STAFF REPORT

TO: HARTFORD PRESERVATION COMMISSION

PROJECT: 55 Elm Street

TYPE: ARTICLE XII HISTORIC PRESERVATION COMMISSION

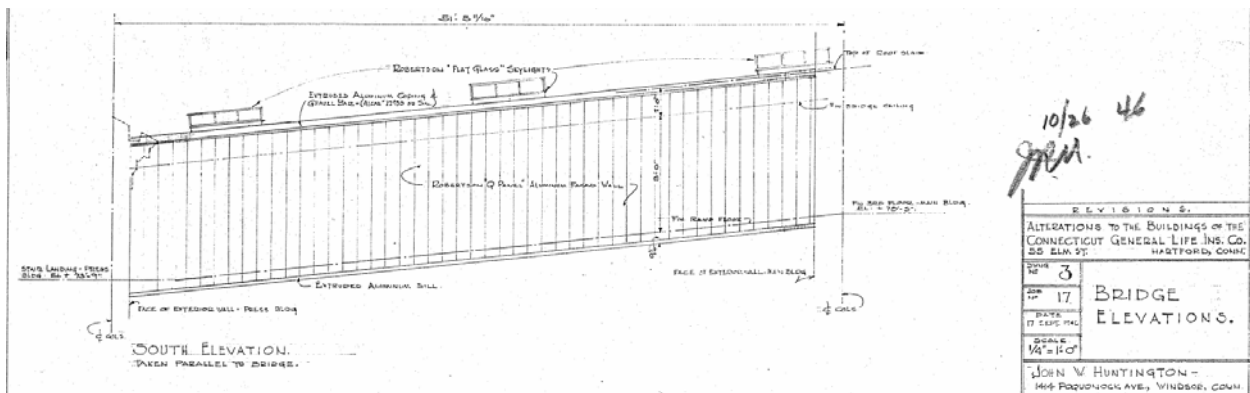
The bridge connection between the top floor of the Annex building and the 3rd Floor of the Main building is shown to remain. While structure could be viewed as an addition deterring from the character and style of the buildings, it is depicted in plans dated September 13, 1946 by John W. Huntington of Windor, Connecticut. Due to its age it may have some significance to construction methods at that time period or other importance that would need to be further explored before the proposal of its removal.
